BAR # 22-11-05 914 Rugby Road. TMP 50145000 Rugby Road Historic Conservation District Owner: Erin and George Sloane Applicant: John Voight / JKV Architects Project: Alterations to front porch, side addition

https://www.charlottesville.gov/264/Historic-Preservation-Design-Review https://gisweb.charlottesville.org/GisViewer/ https://opendata.charlottesville.org/ City of Charlottesville Board of Architectural Review Staff Report November 15, 2022

Certificate of Appropriateness Application (HC District) 914 Rugby Road. TMP 50145000

Rugby Road HC District Owner: Erin and George Sloane Applicant: John Voight / JKV Architects Project: Alterations and side addition

FRONT PORCH DETAIL

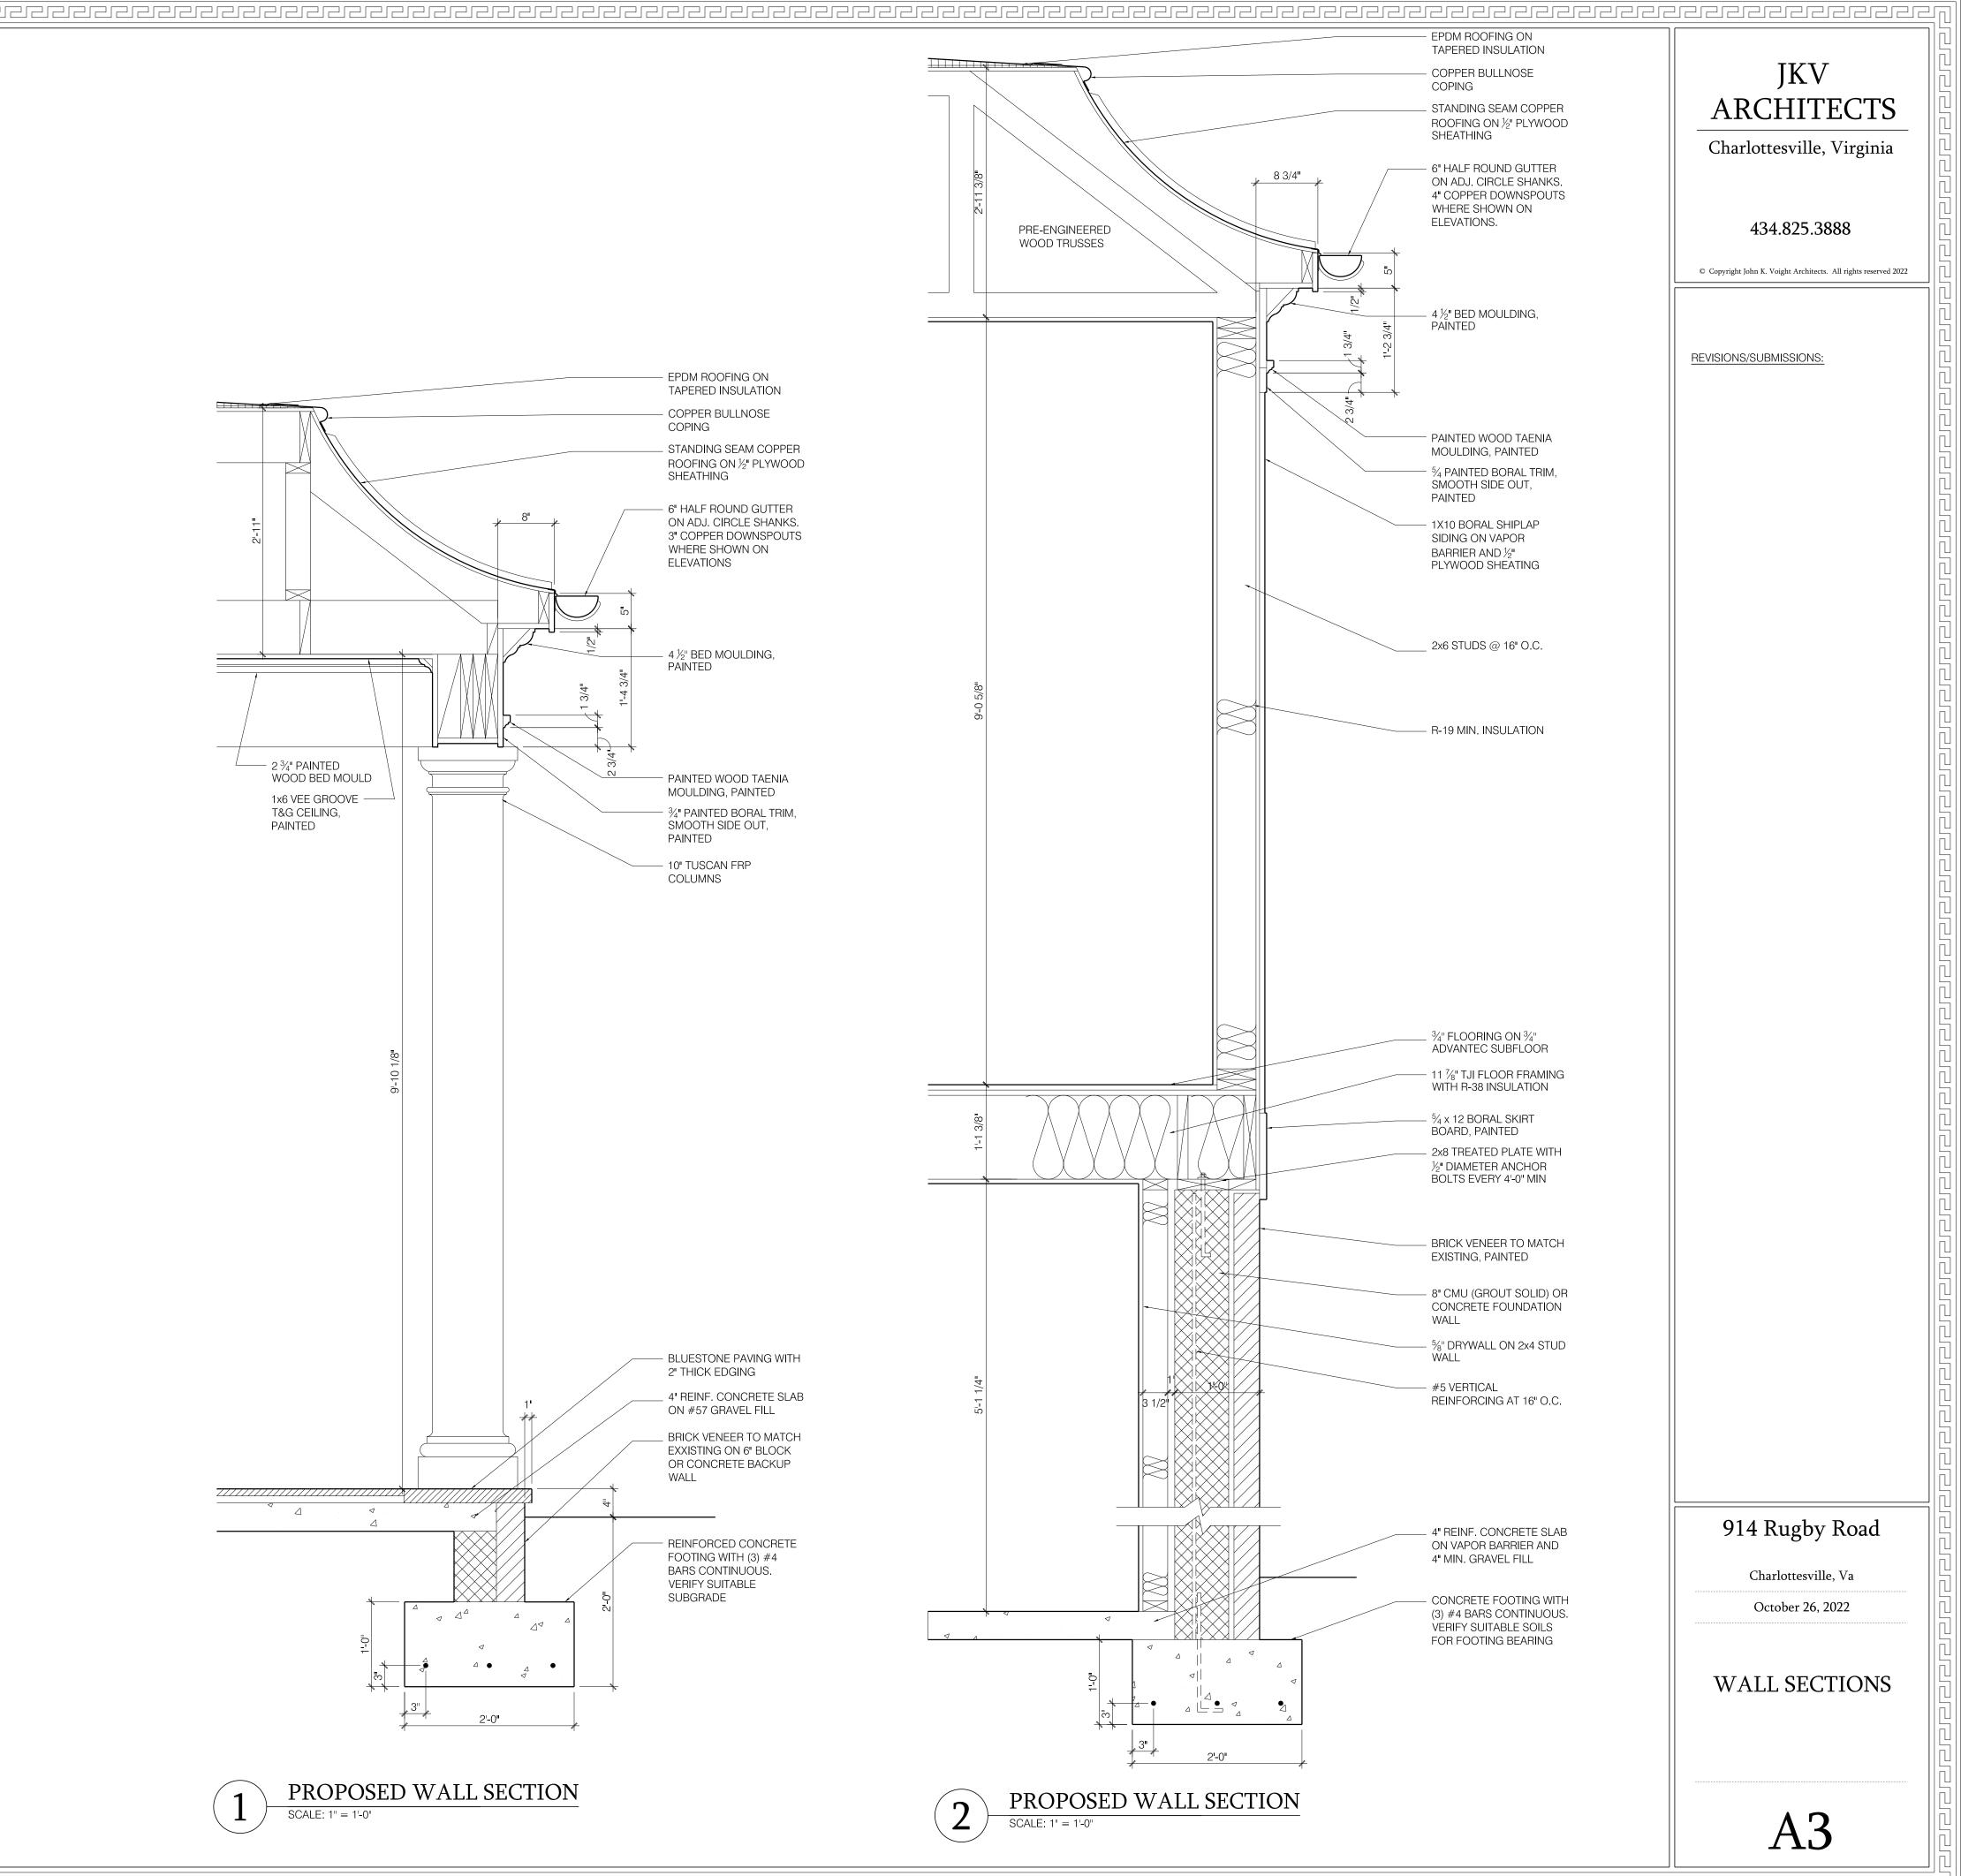
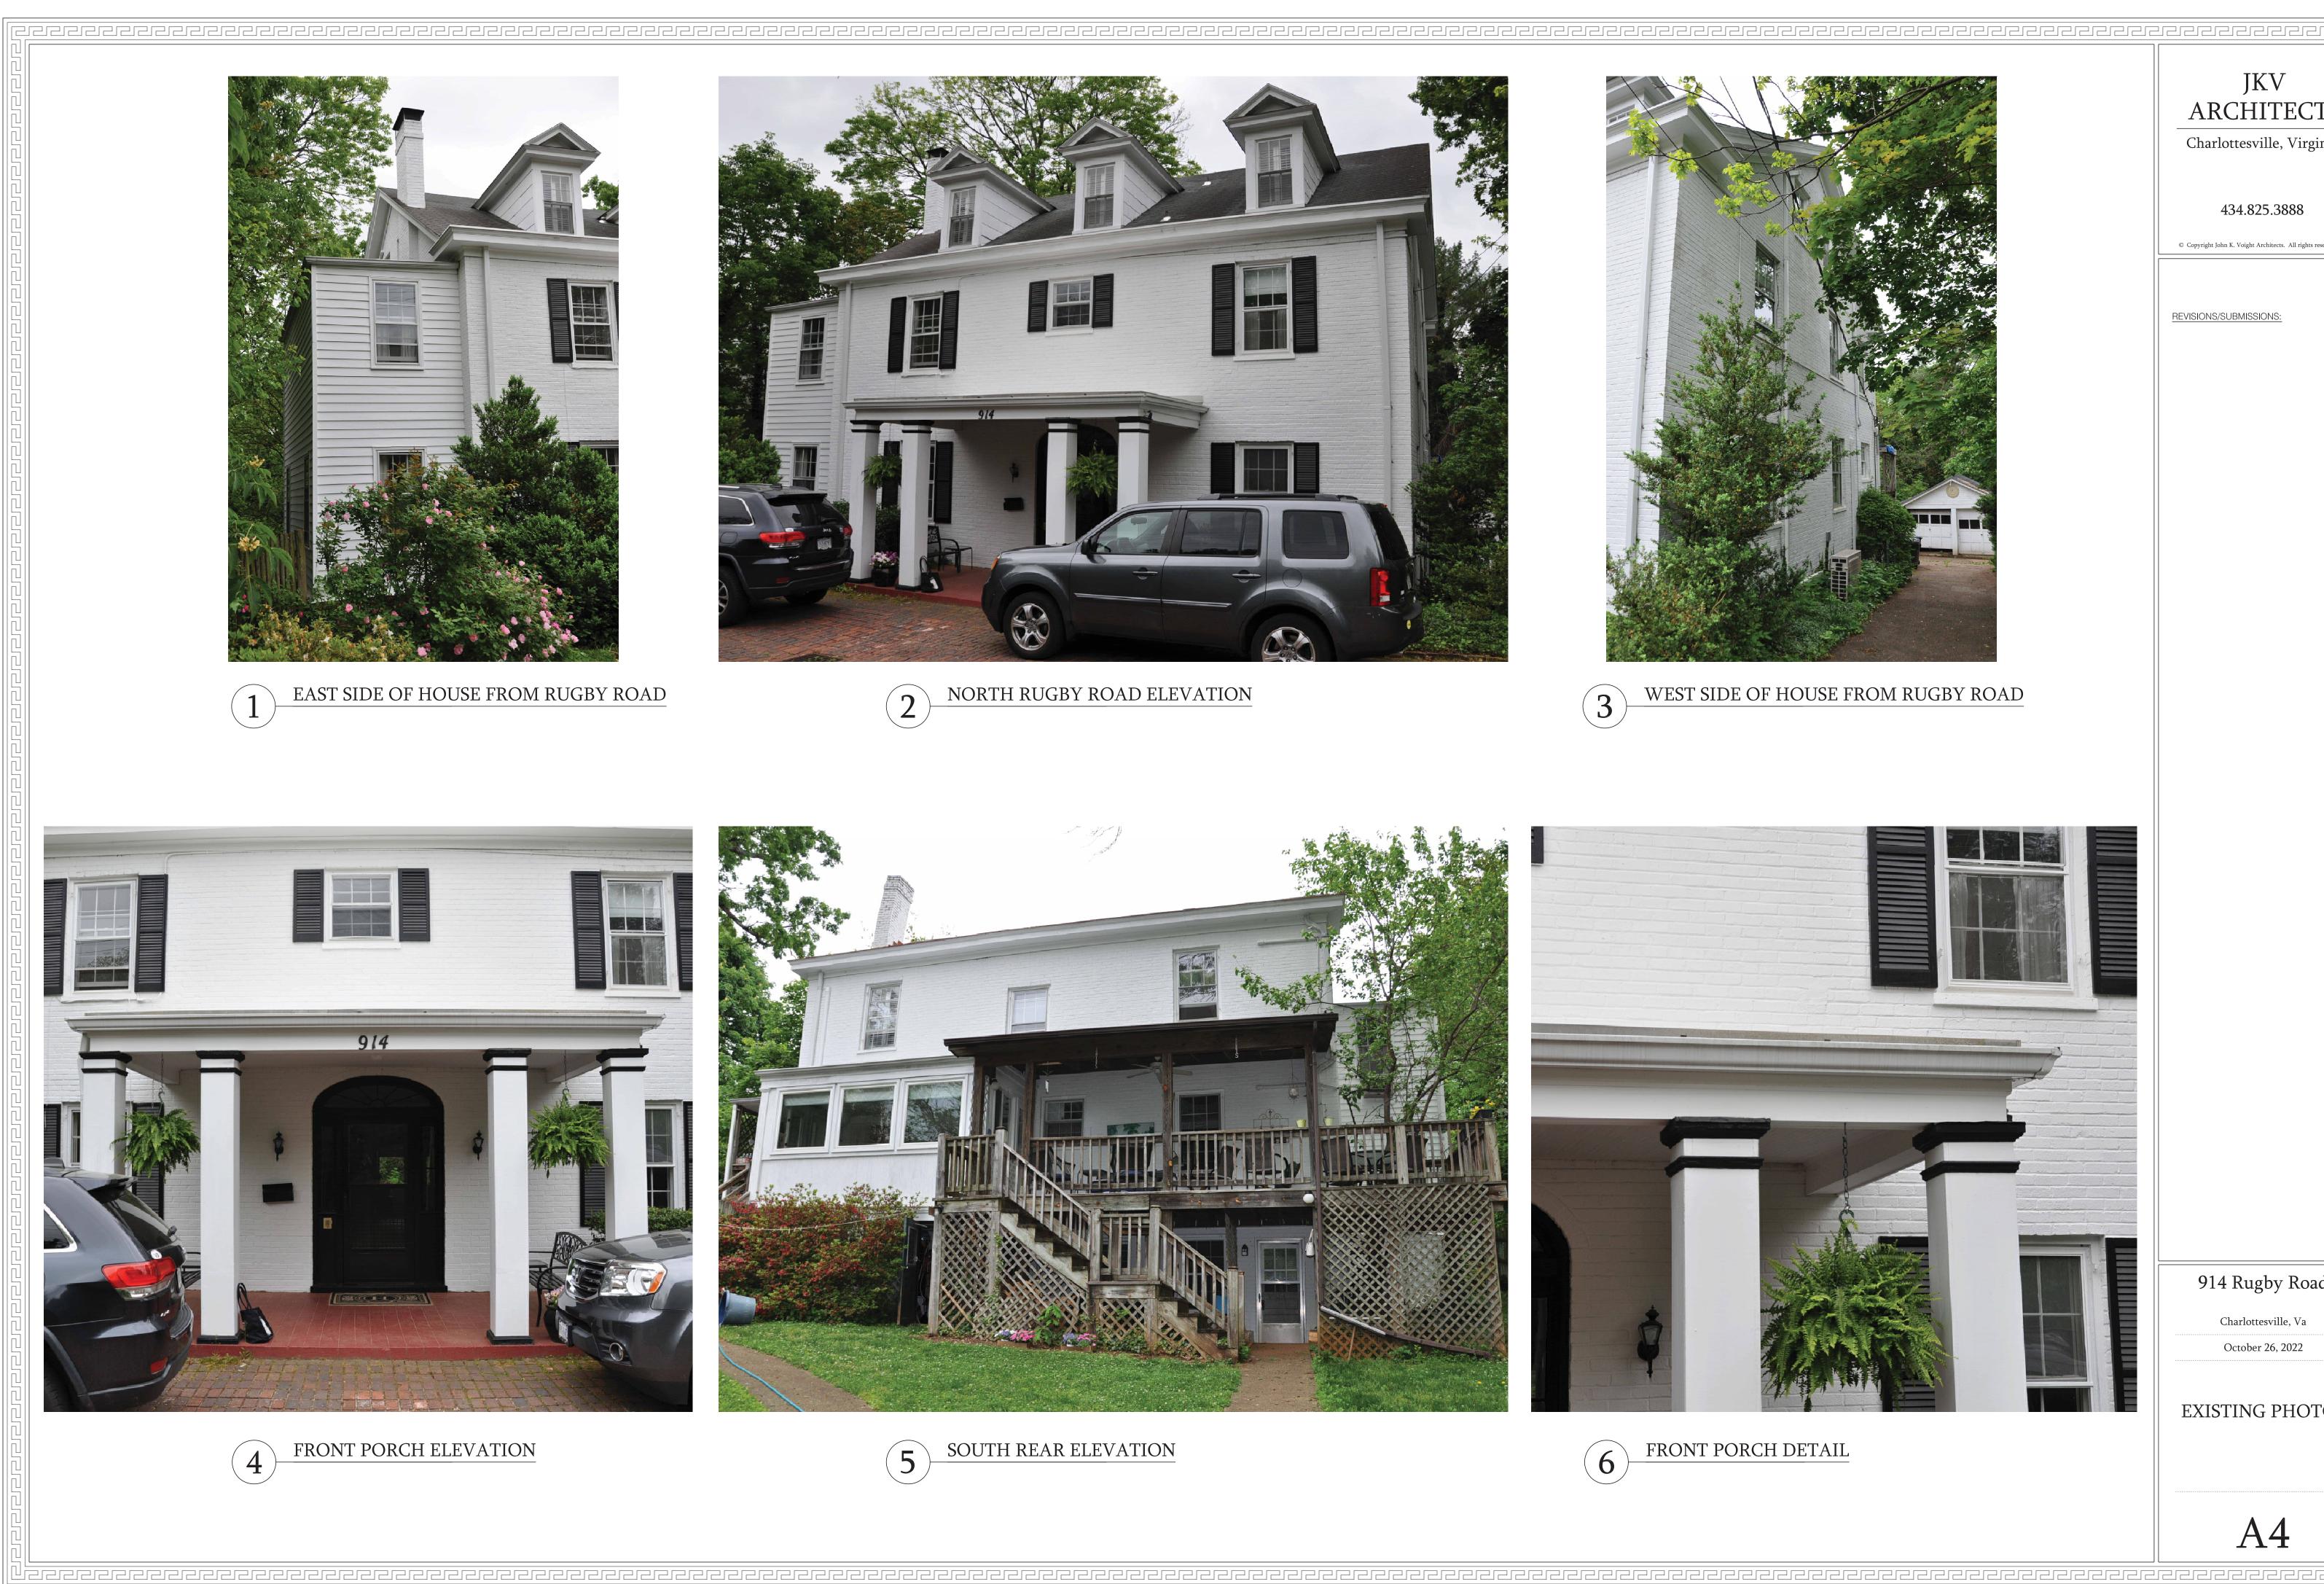
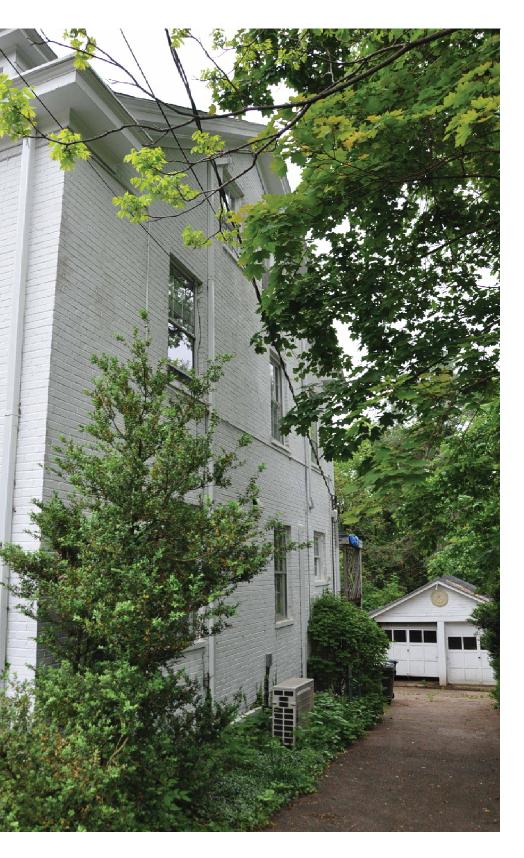
Staff Comment: The addition is compatible with the scale and design of the existing house; the proposed materials, siding, and roof design differentiate the new from the existing. (Re: roof, see staff comment below.)

Staff Comment: Of the 30+ properties in this district, there is no typical style or material for existing roofs in the district. (See attached images.) The BAR should discuss if the proposed mansard-style roof is compatible with the existing house and the district. (See staff comment above.)

Staff Comment: The proposed materials are consistent with the district. Brick, copper, wood and Boral trim and siding, and FRP columns. (The BAR has previously approved the use of Boral FRP materials.)

Staff Comment: Brick repairs to the north (side) will be painted to match the existing masonry.

• <u>Action</u>: Mr. Schwarz_moved: Having considered the standards set forth within the City Code, including City Design Guidelines for Historic Conservation Districts, I move to find that the proposed side addition and front porch alterations at 914 Rugby Road satisfy the BAR's criteria and are compatible with this property and other properties in the Rugby Road Historic Conservation District, and that the BAR approves the application as submitted.
